DANE COUNTY PLANNING & DEVELOPMENT

TO: Town of Rutland
FROM: Dan Everson, Assistant Zoning Adm.
DATE: July 17, 2024
RE: CUP 2582 Mineral extraction summary – Flooding concerns

Street view August 2023 – new culvert for cemetery

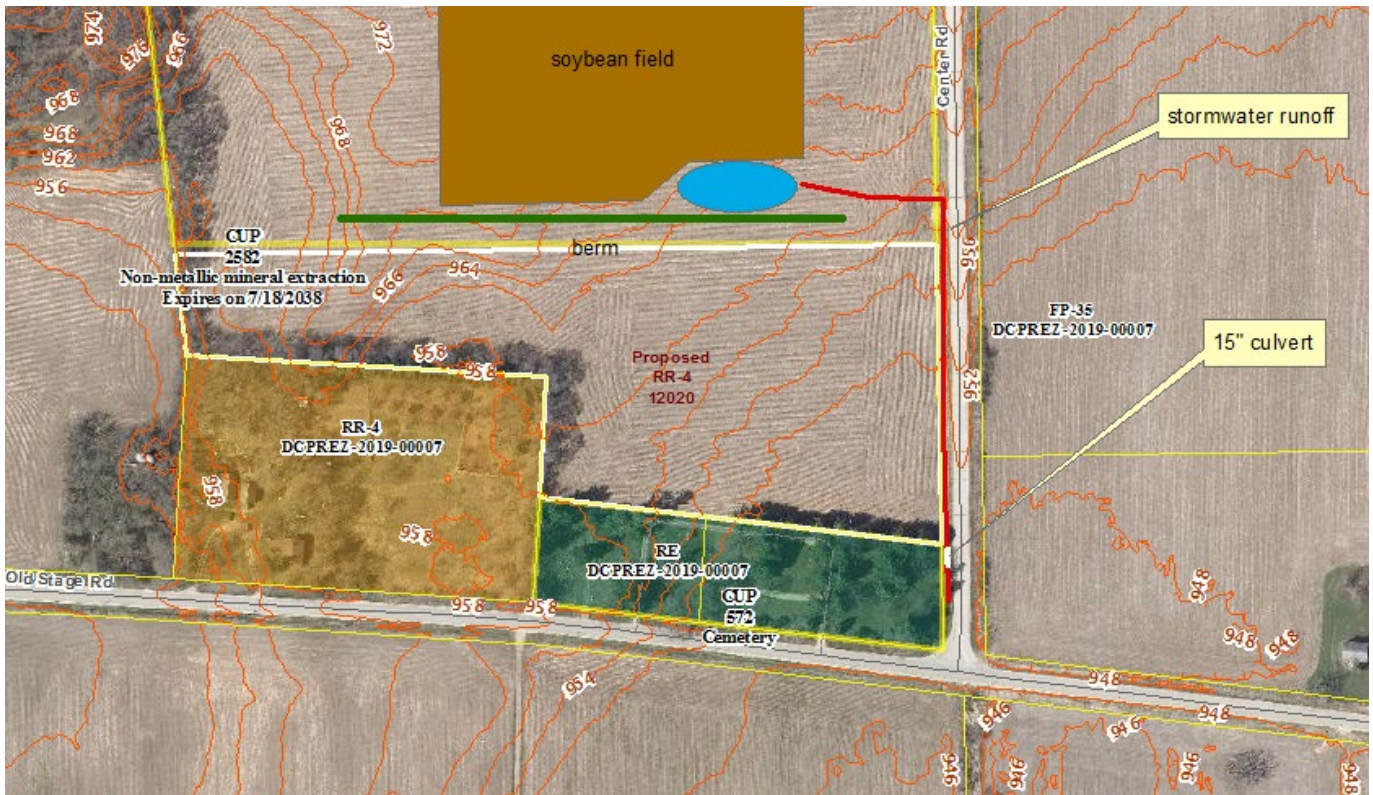
My findings suggest that flooding within the cemetery is for a few different reasons.

- Surface water running southerly from the adjacent agricultural field (CSM lot) to the north.
- Internally standing water within the cemetery in low areas near the narrow access roads. Water can't leave and either evaporates or naturally drains.
- The newly placed culvert along Center Rd. in my opinion is undersized. It has been somewhat flattened on the south end and slightly damaged on the north side. Perhaps an 18" minimum or even greater diameter pipe should be installed.
